**Project #18-032
Foothill Lofts
Located at 1300 North 1200 East**

Project Name: Foothill Lofts
Proponent/Owner: Bracken Atkinson / Laree K. Johnson Trust
Project Address: 1300 North 1200 East
Request: Subdivision & Design Review Permit
Current Zoning: MR-20 & NR-4
Date of Hearing: September 27, 2018
Type of Action: Quasi-Judicial
Submitted By: Russ Holley, Senior Planner

Staff recommends that the Planning Commission **approve** a Subdivision and Design Review Permit for Project #18-032 Foothill Lofts, for 180 multi-family apartment units and 19 single-family building lots located at approximately 1300 North 1200 East; TIN #05-011-0004; -0005.

FOOTHILL LOFTS
 LOGAN, UTAH
 OVERALL SITE PLAN

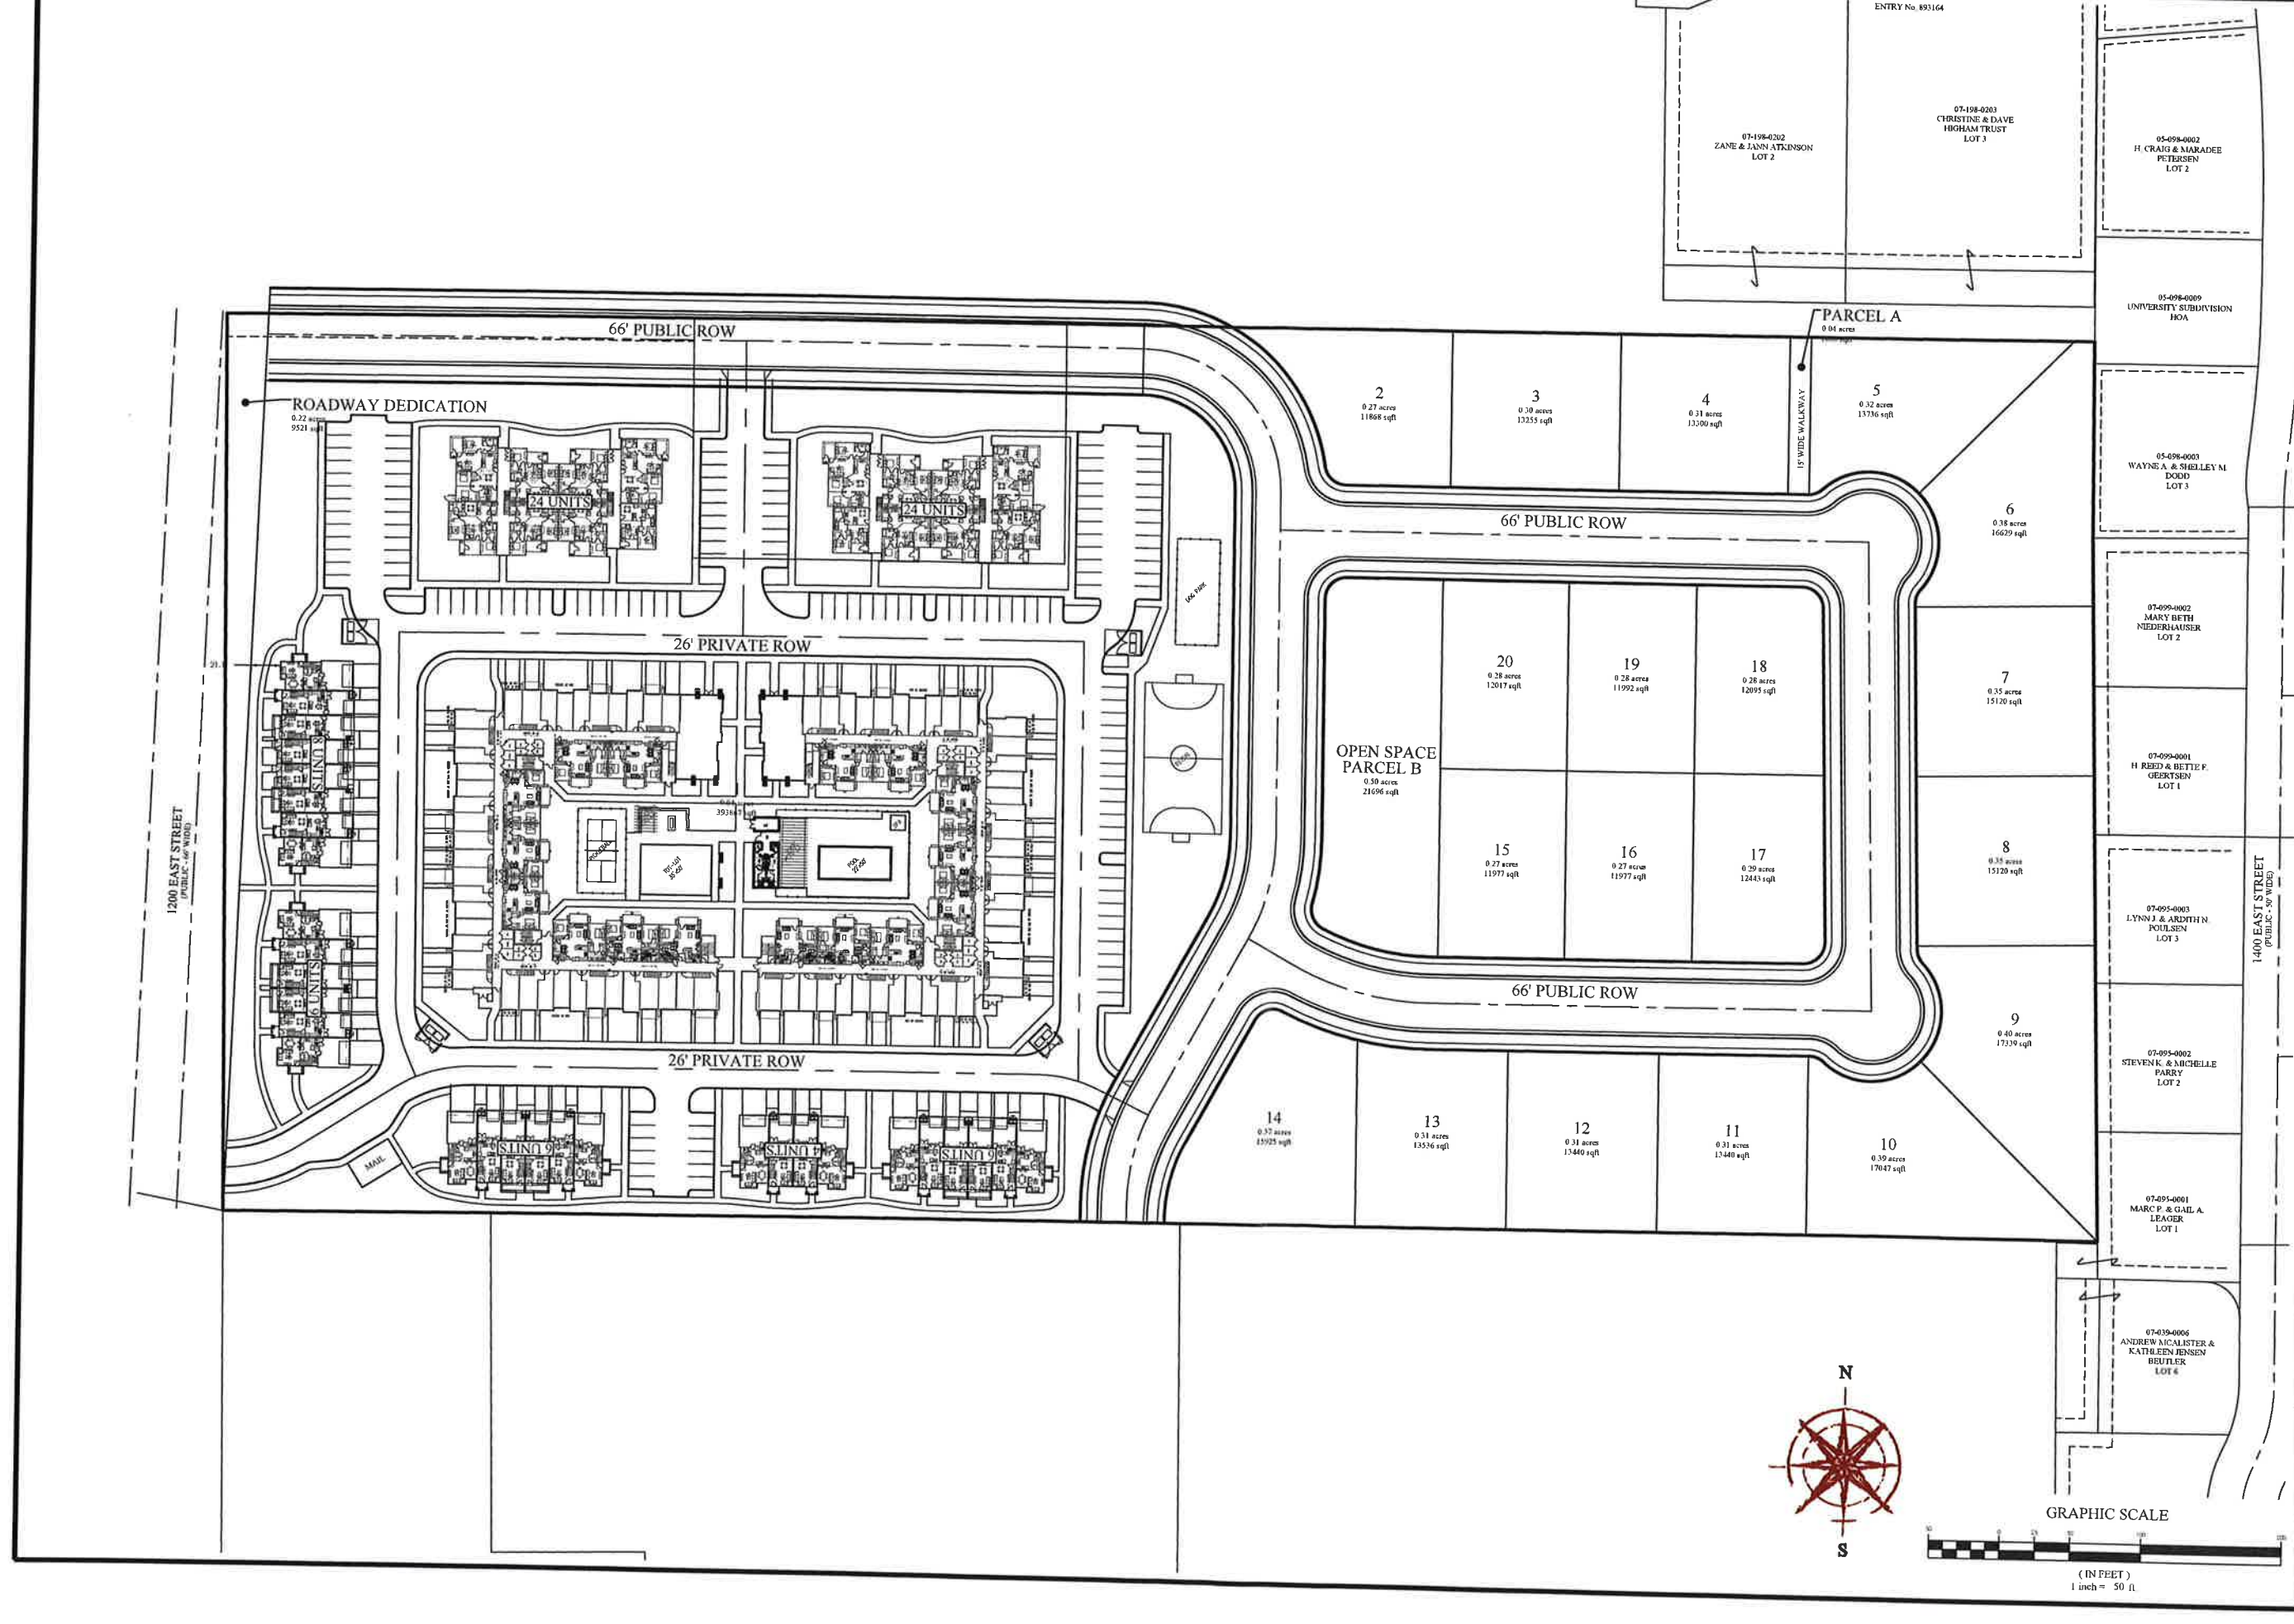
3. Nineteen (19) single family building lots are approved with this subdivision. The area labeled as "Open Space Parcel B" shall only contain landscaping or accessory subdivision amenities such as park play structures and equipment.

APARTMENT SITE PLAN

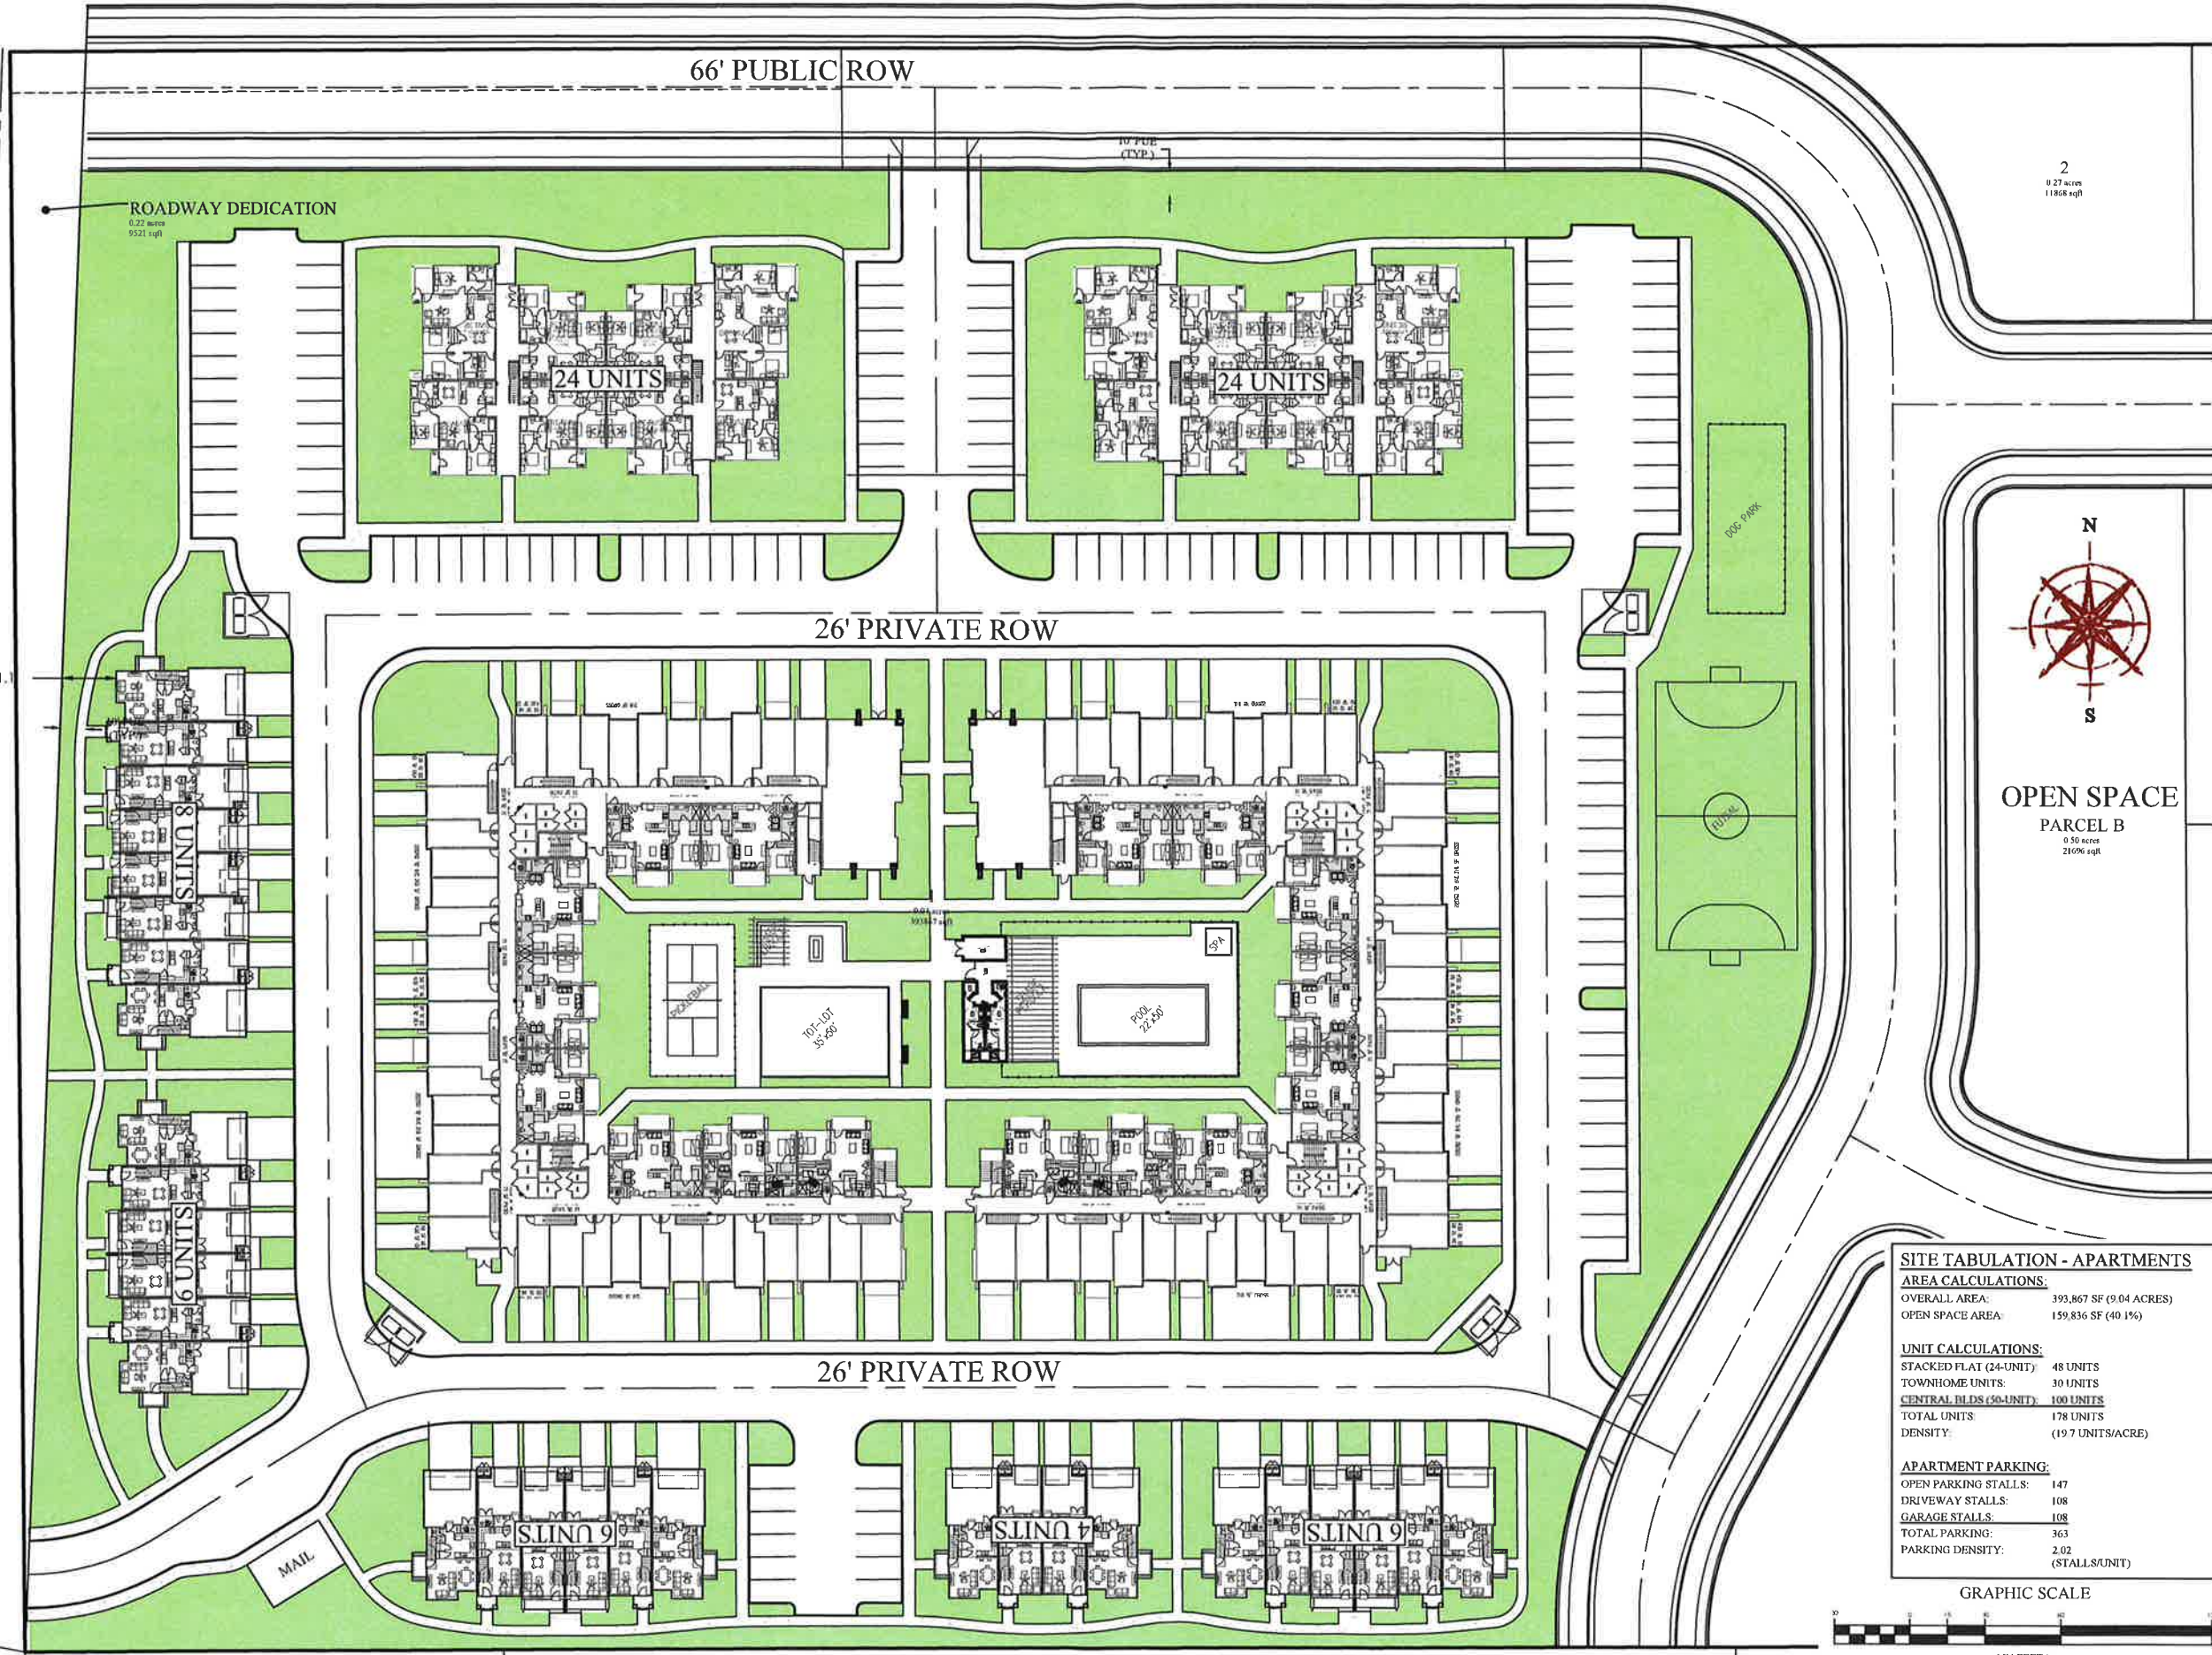
- Change placement of enclosures so the trucks can collect in a counter clockwise direction when entering from the south west corner of the development. SW enclosure can be placed across the street so that it faces north. SE enclosure can be placed across the street so that it faces west. NE enclosure can be placed across the street so it faces south. NW enclosure placement is ok.

- Because the enclosures do not face the entrances, gates are not required. This will also speed the collection process up so that the entrances are not blocked by the collection vehicles longer than necessary.

- The minimum 60 ft. straight on access will be met by using the roads as the access.
- Minimum inside measurement for a double enclosure without gates is 22 ft. wide and 10 ft. deep. Place bollards in the back and on the corners of enclosures to help protect walls.
